BCA & DDA ASSESSMENT REPORT

**DOOLEYS LIDCOMBE CATHOLIC CLUB
JOHN STREET, LIDCOMBE NSW**

Revision 3

24 June 2016

Basement Level B1 Fire Wall location

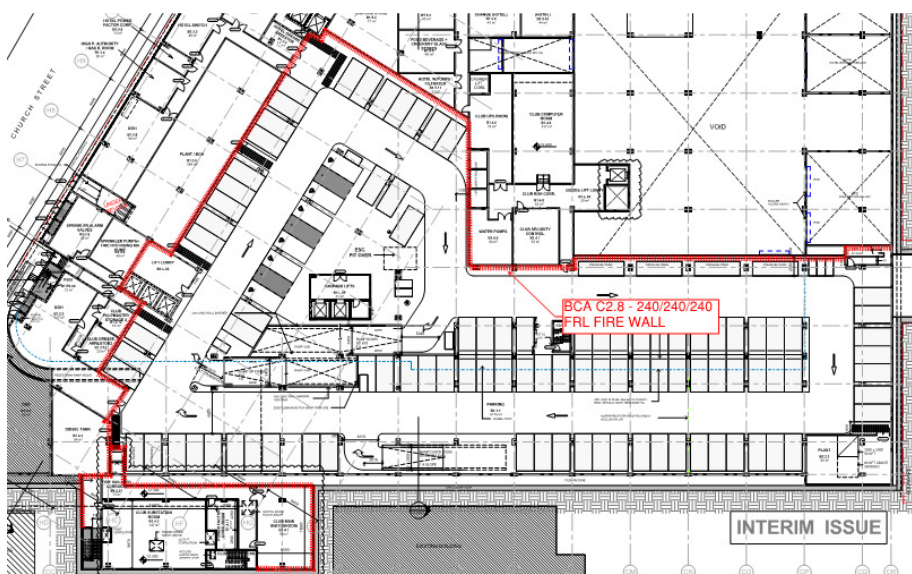
Comments: Compliance is readily achievable. Note: See C2.8 below – a fire wall is required on Basement Levels B1 and B2 to separate the Class 7a Carpark areas from the Class 7b Loading Dock, Plantroom and Storage areas.

Comments: On Basement Levels B1 and B2 the Class 7a Carpark areas from the Class 7b Loading Dock, Plantroom and Storage areas are located adjacent to each other on the same storey and have differing FRL requirements (Class 7a – 2hrs & Class 7b – 4hrs). As such in accordance with C2.8(b) and 240/240/240 FRL fire wall is required to separate these areas on these levels in order to apply the lower FRL in the Class 7a portions of these storeys.

Basement Level B2 Fire Wall location

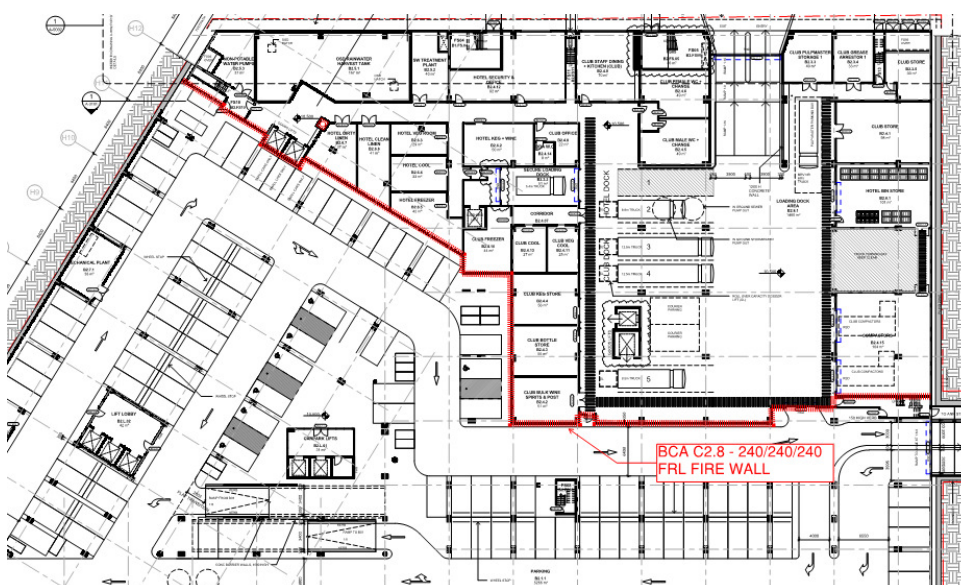
It is noted that an alternative solution may be considered by the Fire Safety Engineer for a reduced FRL of the subject fire walls and the building elements within the Class 7b/8 portions of these floors.
